UNITED STATES PATENT AND TRADEMARK OFFICE

APPLICATION NO.	FILING DATE	FIRST NAMED INVENTOR	ATTORNEY DOCKET NO.	CONFIRMATION NO.
10/798,014	03/10/2004	Tae-ahn Jahng	559552000120	4949
25225 7590 02/04/2008 MORRISON & FOERSTER LLP 12531 HIGH BLUFF DRIVE SUITE 100 SAN DIEGO, CA 92130-2040			EXAMINER CUMBERLEDGE, JERRY L	
			ART UNIT 3733	PAPER NUMBER
			MAIL DATE 02/04/2008	DELIVERY MODE PAPER

Office Action Summary	Application No.		Applicant(s)	
	10/798,014		JAHNG, TAE-AHN	
	Examiner		Art Unit	
	Jerry Cumberledge		3733

DETAILED ACTION

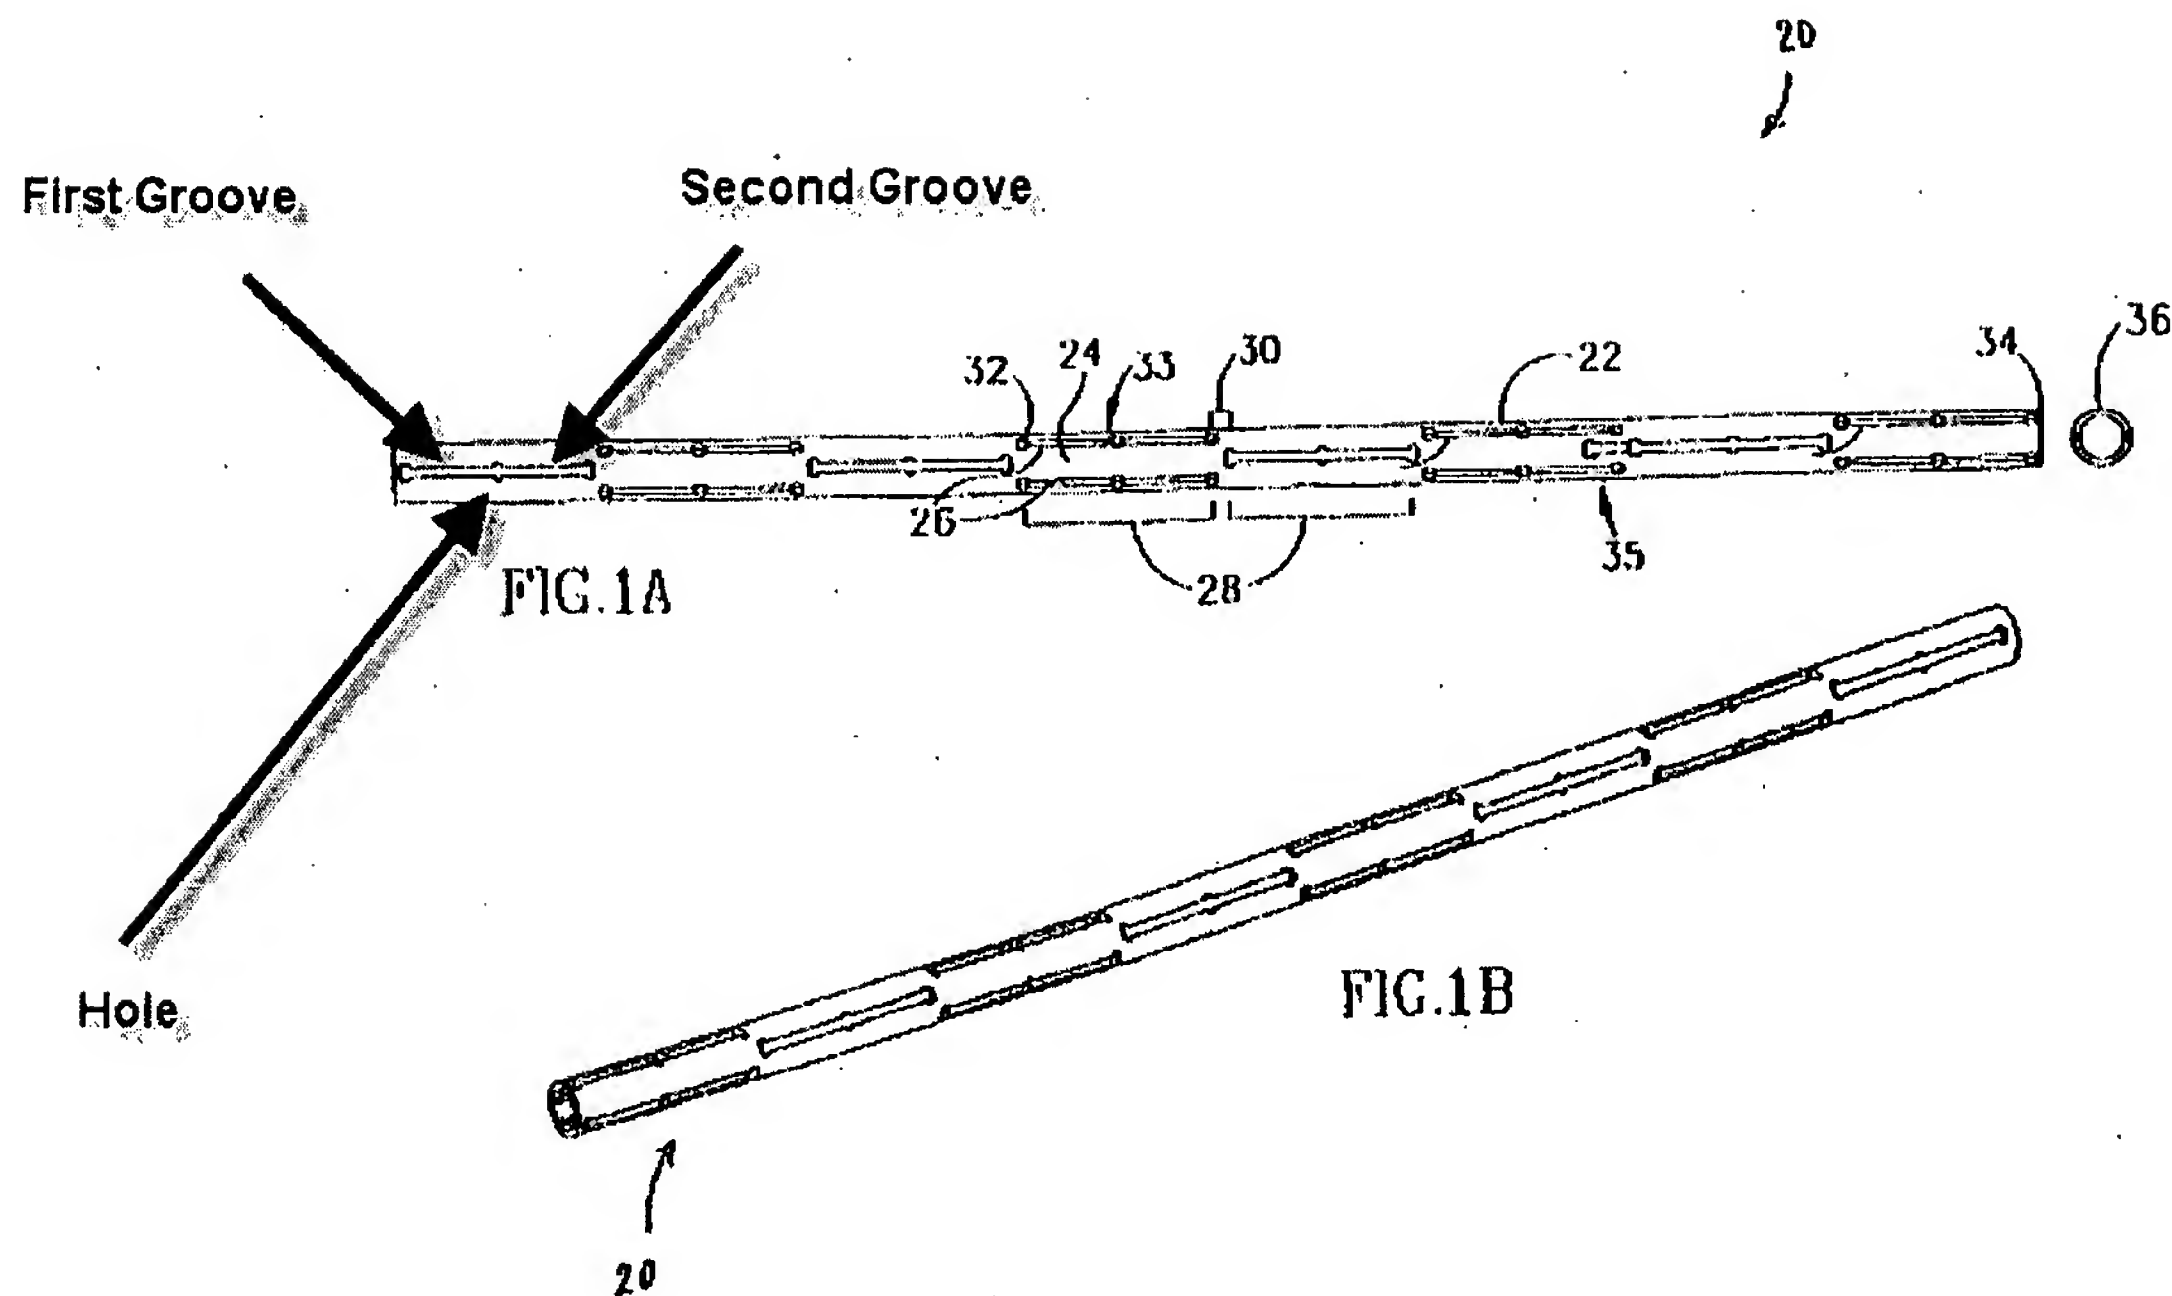
Paul et al. disclose the claimed invention except for at least two of the plurality of grooves directly coupled on the center section surface by an hole, and the hole at least twice as wide as the coupled grooves average width. The flexible connection unit further includes a plurality of transverse tunnels formed within at least a portion of the solid longitudinal section and wherein each tunnel coincides with at least one hole. Each transverse tunnel passes through a center longitudinal axis of the cylindrical rod such that openings for each respective transverse tunnel are located on opposite sides of the cylindrical wall of the rod and coincides with at least one hole. Each of said plurality of transverse tunnels have an internal diameter between 0.2 and 3 millimeters.

Globerman et al. disclose a flexible member (Fig. 1A, ref. 20)(Fig. 1C) at least two of the plurality of grooves directly coupled on the center section surface by a hole (Fig. 1A, below). The flexible connection unit further includes a plurality of transverse tunnels formed within at least a portion of the solid longitudinal section and wherein each tunnel coincides with at least one hole (Fig. 1A, Fig. 1C). Each transverse tunnel passes through a center longitudinal axis of the cylindrical rod such that openings for each respective transverse tunnel are located on opposite sides of the cylindrical wall of the rod and coincides with at least one hole (Fig. 1C). The holes are defined within the grooves in order to reduce the propagation of stress and/or mechanical failure in the rod (column 9, lines 16-19).

It would have been obvious to a person having ordinary skill in the art at the time the invention was made to have constructed the rod of Paul et al. with grooves and holes as taught by Globerman et al., in order to reduce the propagation of stress and/or mechanical failure in the rod (column 9, lines 16-19).

Paul et al. in view of Globerman et al. disclose the claimed invention except for the hole being at least twice as wide as the coupled grooves average width. It would have been obvious to one having ordinary skill in the art at the time the invention was made to have the hole twice as wide as the coupled grooves, since it has been held that discovering an optimum value of a result effective variable involves only routine skill in the art. In re Boesch, 617 F.2d 272, 205 USPQ 215 (CCPA 1980).

Paul et al. in view of Globerman et al. disclose the claimed invention except for each of said plurality of transverse tunnels have an internal diameter between 0.2 and 3 millimeters. It would have been obvious to one having ordinary skill in the art at the time the invention was made to have constructed the plurality of transverse tunnels having an internal diameter between 0.2 and 3 millimeters, since it has been held that where the general conditions of a claim are disclosed in the prior art, discovering the optimum or workable ranges involves only routine skill in the art. In re Aller, 105 USPQ 233.
